## BUILT IN DUAL SPECTRUM CHIRP ULTREX/FORTREX ADPT CABLE INCORRECT

**Affected Models:** Fortrex, Ultrex, and Ultrex Quest Equipped with DSC.  
1368667, 1368677, 1368668, 1368890, 1368891, 1368895, 1368896,  
1368900, 1368901, 1368902, 1368894

**Related Part Numbers:** 490575-2/2886302

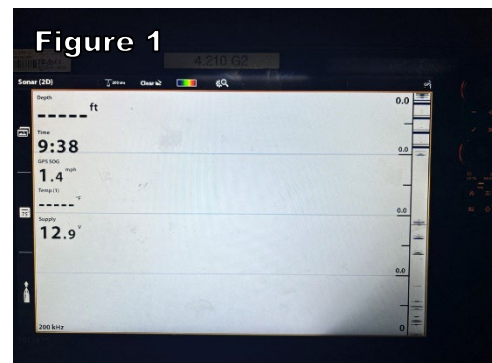
The resistor that is used to identify sonar type was installed across the wrong pins; due to this a Solix or Apex unit will not identify that a transducer is connected and will not “ping” the transducer, Figure 1 is a Solix Unit displaying the 2D Sonar Screen that should be expected when connected to a DSC motor with a faulty 490575-2.

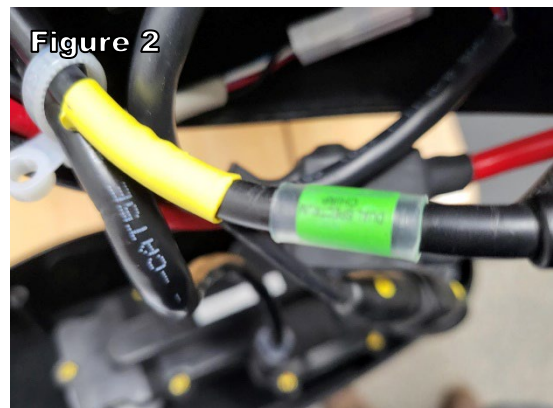
Suspect Cables will have a small green shrink with “Dual Spectrum Chirp” printed on it, and a slightly larger, yellow heat shrink, on the control box end of the cable, and no other factory markings. (Figure 2). Any other factory markings suggest the suspect cable has been replaced with a newer one.

**Actions:** Contact Minn Kota Customer Service for replacement of any 490575-2 shipped from Minn Kota prior to 17 May 2024 with Kit 2886302 (490575-2 w/Installation instructions and necessary tie wraps).

When performing any service on an affected motor replace suspect 490575-2 with 2886302 Kit and file a warranty claim for that repair.
